## Engineering Change Notification

### NHD-0416BZ-NSW-BBW

Old Design	New Design

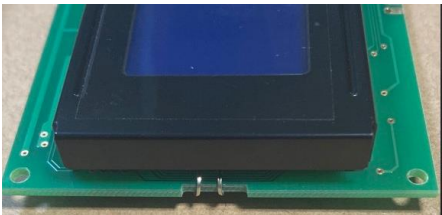
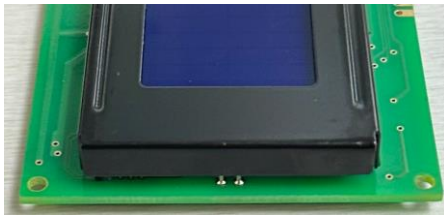
The backlight and PCB used in the manufacturing of this display have been redesigned to improve the anode and cathode connections between the backlight module and display PCB.

- Backlight: Mechanical structure modified. No change to input power requirements.
- PCB: Cutout for backlight leads removed and replaced with a straight edge on the board.

All our testing found the new version to be backwards compatible with existing systems.

The new display will be labeled with a **Rev1A** identifier after the part number.
